TECHNICAL IMPROVEMENT PROGRAM

Label Infeed Stop Fingers Air Cylinder Assembly

TIP-10004

Model EM

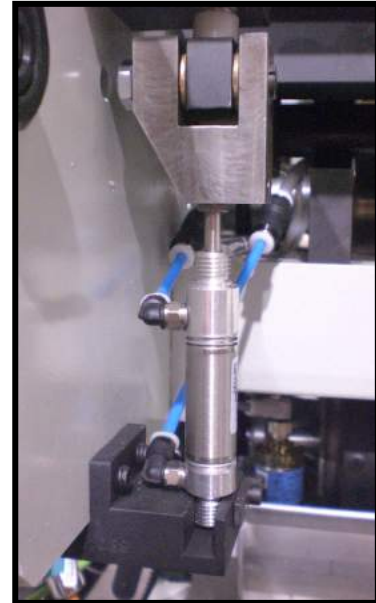
This label infeed stop fingers air cylinder assembly replaces the earlier version that had a straight clevis design and excess mass. This assembly's design has been upgraded to reduce the mass/weight and provides increased precision for the stop fingers to properly stop and square the label.
